Unclassified Version of a November 1989 Report to the Chairman, Committee on Armed Services, House of Representatives

ABRAMS TANK

Block II Modifications Not Ready to Enter Production

B-235418

Figure 4.1: Dates of Funding Decisions and Testing for the M1A2

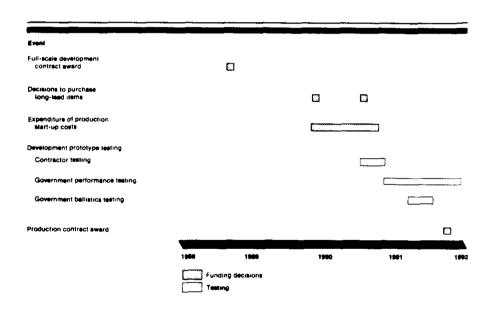
The Army's compressed acquisition schedule further increases the risk of the Block II program. The Army will commit \$166.4 million in advanced procurement funding for production long-lead items and to prepare the tank assembly line for production before development prototype testing begins. Decisions to purchase \$39.4 million of long-lead items for production are scheduled for November 1989 and July 1990. In addition, nonrecurring production start-up costs of \$127 million are to be expended throughout fiscal year 1990 in preparation for production. However, Army testing of development prototype tanks is not scheduled to begin until early in fiscal year 1991 after advanced procurement funds are committed to Block II production.

As shown in figure 4.1, advanced procurement decisions are scheduled for November 1989 and July 1990 to buy long-lead items for production and to invest in nonrecurring production items. The November 1989 decision is to be made about 8 months before contractor testing of development prototype tanks begins. The July 1990 decision is to be made 3 months prior to the start of Army testing in October 1990. Consequently, the Army plans to make advanced production commitments before Army testing of prototype vehicles begins.
